With reference to the room erected on plot No. 16, K-11 Lyari Quarter, Mr. Haji Mahomed Ibrahim, owner of the plot is informed, the Managing Committee at their meeting held on 23rd September 1919 passed the following resolution with regard to the above plot.

34. Endorsement dated 16th June 1919, by the Acting Chief Officer, submitting papers re-unauthorized work carried out on temporary plot No. 16, K-II, Lyari Quarter, by Mr. Haji Mahomed Ebrahim and requesting sanction to demolish the same and prosecute the owner. Deferred from the last meeting.

PLAN OF PROPOSED STORE-ROOM

ON PLOT № 16-K.11

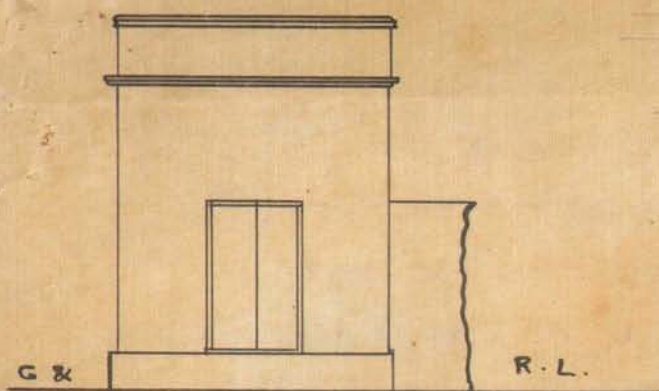
Mr. Vansan: This is not
correct. It should
be K11. M. Shamma
11/4/19

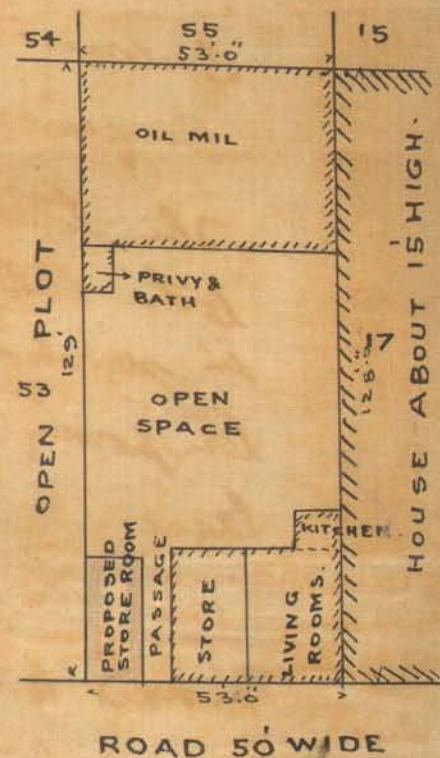
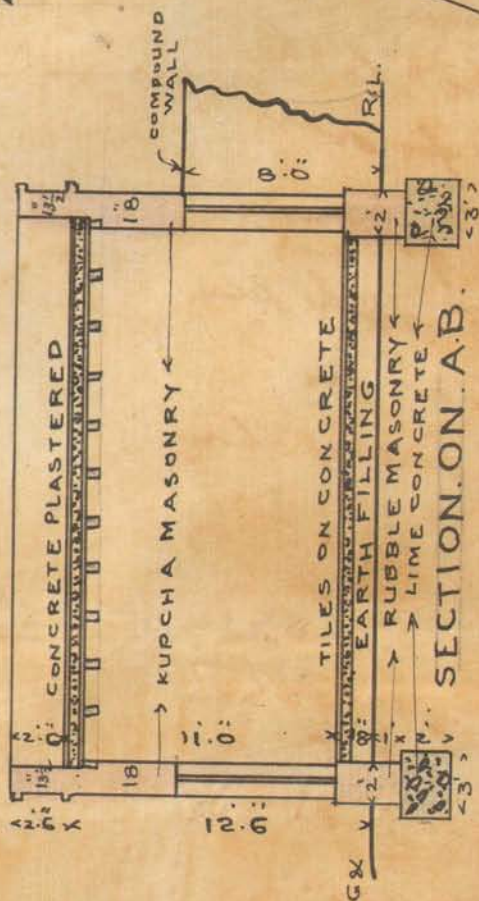
With reference to the room erected without permission on plot No. 16, K-11, Lyari Quarter, Mr. Haji Mahomed Ibrahim owner of the above plot is informed, that a permanent structure on a temporary plot cannot be allowed. The plan is herewith returned disapproved.

With reference to his application dated 25th ultimo with plan for the proposed room on plot No. 16, 1st Myari Quarter Mr. Haji Mahomed Ebrahim is informed that permanent structure on temporary plot cannot be allowed. The proposed building interferes with the ventilation of the existing one and is objectionable.

*Position of store room is
objectionable. It interferes
with the ventilation of the living
bedding rooms*

Building Surveyor's Report Sir, The plot is temporary
& no building on this is objectionable.

Remarks Sir, I beg to report that the room as shown
cannot be allowed to build on temporary
plot. The applicant has asked to get the
plan converted into permanent lease when
it has to be considered. The structure interferes
the existing building.

Insufficient structure cannot be allowed on
a temporary plot. The proposed building
interferes with the ventilation of the existing
one & is objectionable. The plan is disapproved.

The plan is herewith returned disapproved.

UNAUTHORIZED ROOM ON PLOT 16-K-II

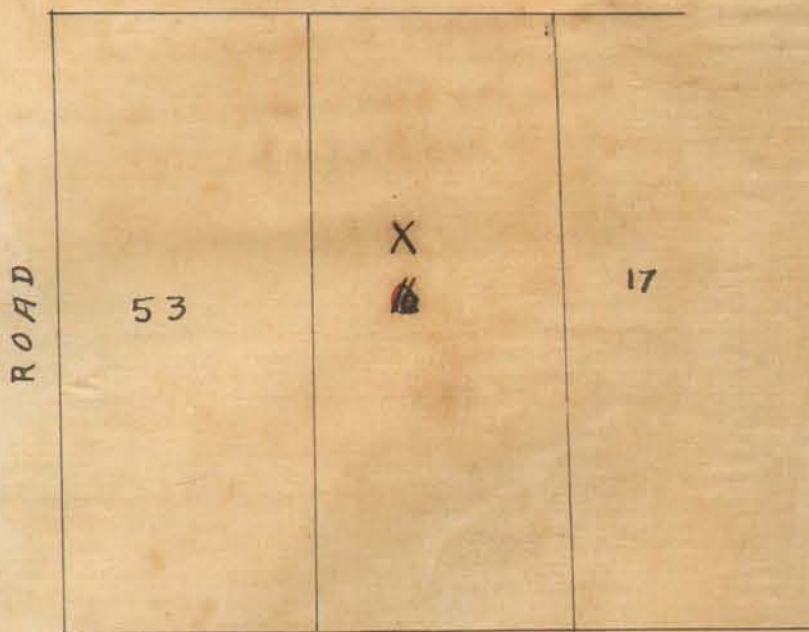
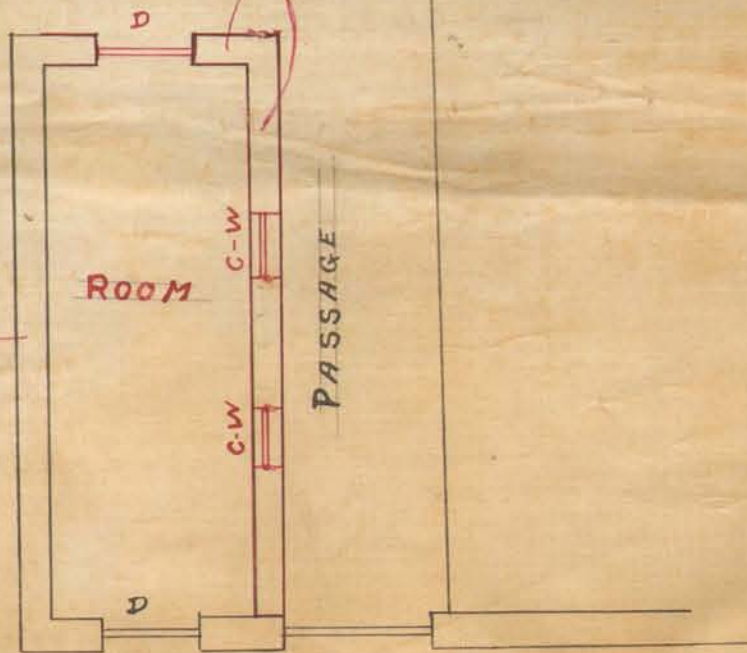
With reference to the attached correspondence, they herewith submit herewith a tracing showing in red the walls erected ~~without~~ without permission which is now stopped and maybe used hereafter as a room.

I report that the applicant has
erected the Room but not covered
its top. The unauthorized
work should be pulled down
